UNITED STATES PATENT AND TRADEMARK OFFICE

APPLICATION NO.	FILING DATE	FIRST NAMED INVENTOR	ATTORNEY DOCKET NO.	CONFIRMATION NO.
10/523,972	02/08/2005	Eiji Kadouchi	43890-715	1562

Office Action Summary

DETAILED ACTION

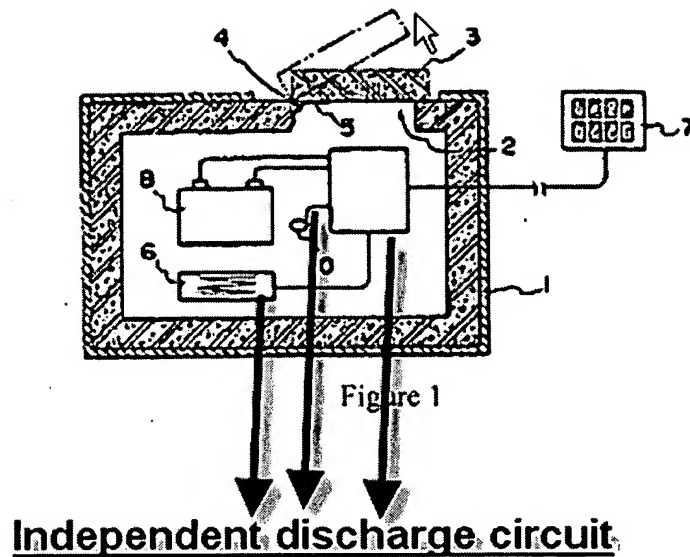
Regarding Claim 1, Hashiguchi et. al. disclose in Figures 1-2, a battery storing device comprising: a battery (8) storing section (1) that can store a battery inside and has a heat retaining function of retaining heat of the battery that is stored inside using heat insulating material (the box is a hermetically-sealed heat-insulated box, see abstract and Claim 1); and a heat retention releasing mechanism (an air flowing door 3) for releasing the heat retaining function, an independent discharge circuit having a heating resistor (6).

(see figure below)

Wherein the heat retention releasing mechanism (3) opens and closes an opening for making air flow between the inside and outside of the battery storing section (1) (noted that element 2 and 3 is used as a means of air flowing in and out from the box 1, see Abstract). Hashiguchi et. al. do not disclose explicitly, said independent discharge circuit is directly coupled to the battery and can perform discharge independently from the charge/discharge operation of a main circuit. However, McCall discloses in Figures 1-4, said independent discharge circuit (heat discharge warmer circuit) is directly coupled to the battery (the warmer (the heater) circuit of McCall is wrappable heating unit that is wrapped around the battery, see Column 3, lines 30-34) and can perform discharge independently from the charge/discharge operation of a main circuit (see Column 1, lines 58-62, Column 3, lines 1-15, and Column 19-34). It would have been obvious to a person having ordinary skill in the art to substitute Hashiguchi et. al. heater

Element 6, of Figure 1 of Hashiguchi discloses a heating resistor.
